**Environmental
Planning
Commission**

**Agenda Number: 06
Project Number: 1003275
Case #: 16EPC-40055
January 12, 2017**

Staff Report

Agent	Modulus Architects
Applicant	Palo Alto Inc.
Request	Site Development Plan for Building Permit
Legal Description	Tract C-3, Plat of Tracts A-1 Thru A-3 and C-1 Thru C-3, Heritage Marketplace
Location	On Unser Boulevard between Ladera Drive and Interstate 40
Size	Approximately 1.13 acres
Existing Zoning	SU-2/SU-1 for Planned Office Park and Commercial Development to Include Full Service Alcohol Sales with a Sit Down Restaurant
Proposed Zoning	No change

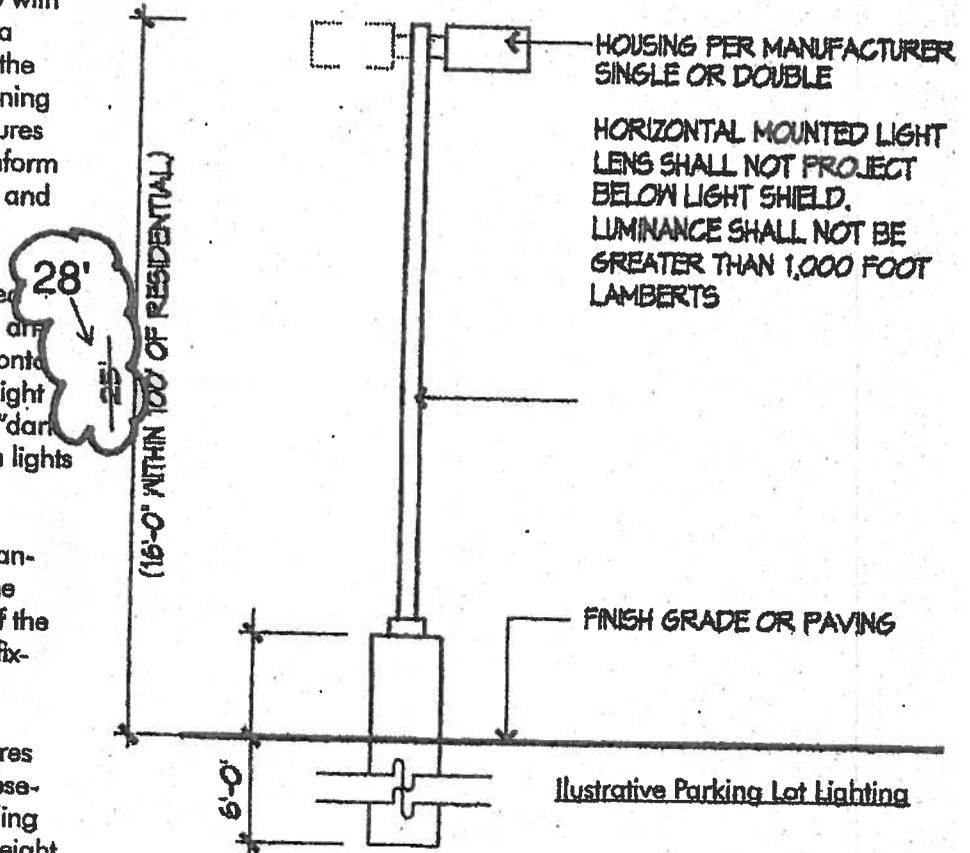
Why did you cross out this sentence regarding the non- illuminated - logo signage?

How many illuminated logo signs are you proposing?

SITE PLAN REDUCTIONS

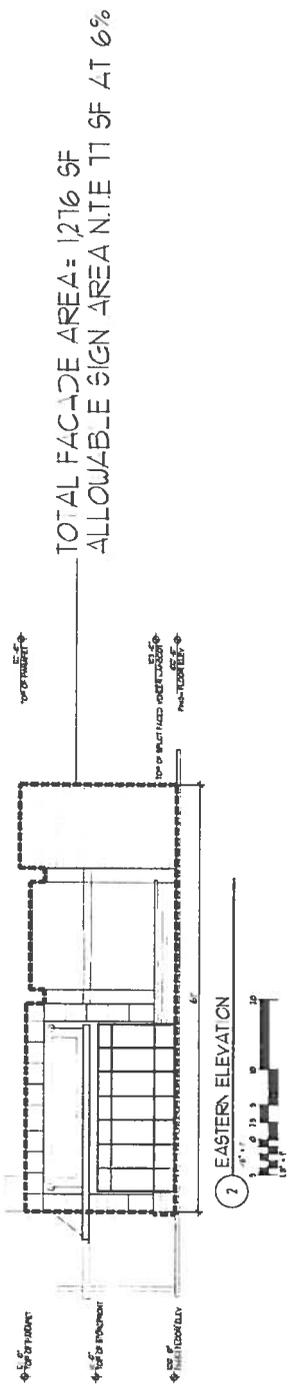
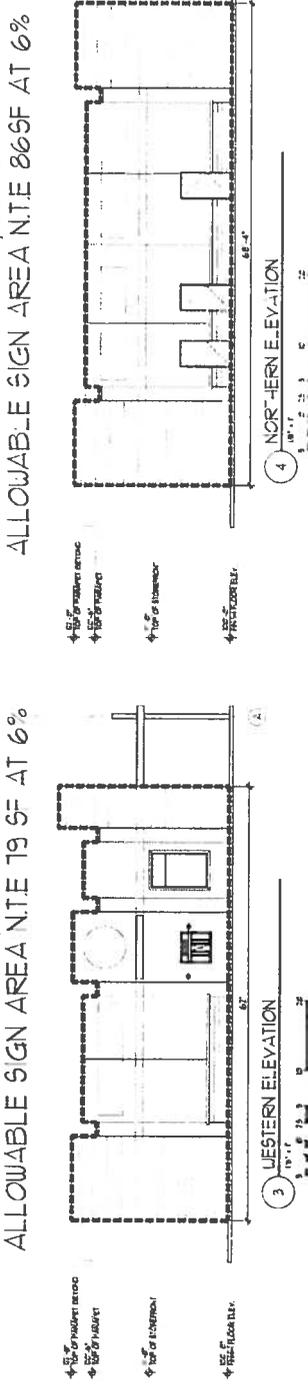
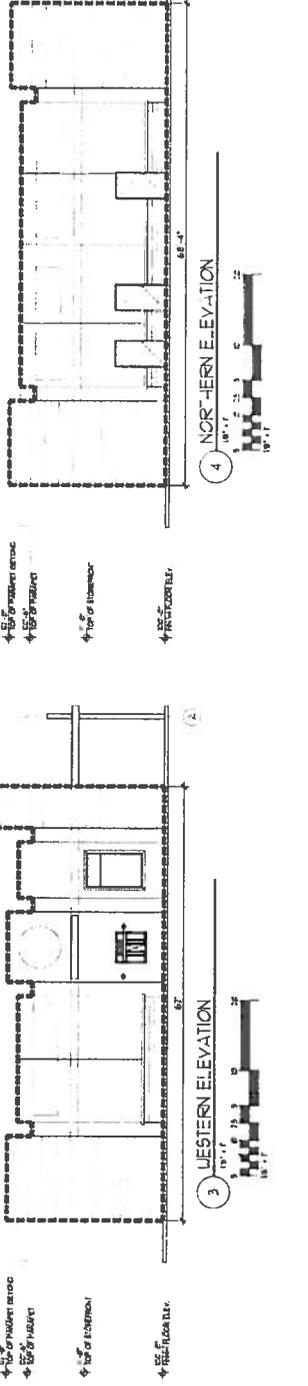
6. Signage (A4.1):
- A. The following notes shall be added:
 - e. Per design standard 5.13 "All Wall-mounted signs shall be individual type lettering."
 - f. Per design standard 5.14 "Wall mounted signs shall not project more than 1 foot."
